Service Bulletin

No. : MZ02-017

Model: SR7200

Subject: Pop noise when powering the set ON.

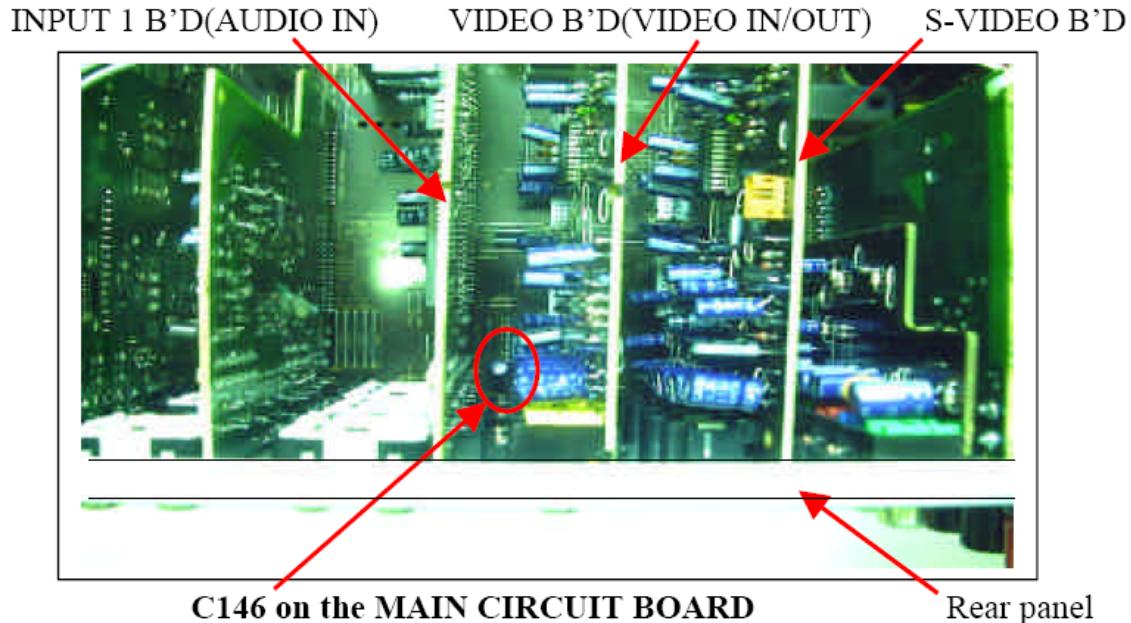
Symptom: A pop noise is heard from the Center speaker, Surround L/R and Surround Center speaker when powering the set ON.

Solution: Change the Electrolytic capacitor C146 (10uF/50V) to a 47uF/16V. C146 is located on the MAIN circuit board.

Ref #	FORMER		NEW	
	Description	Part Number	Description	Part Number
C146	10uF/50V	NA	47uF/16V	EA47601610
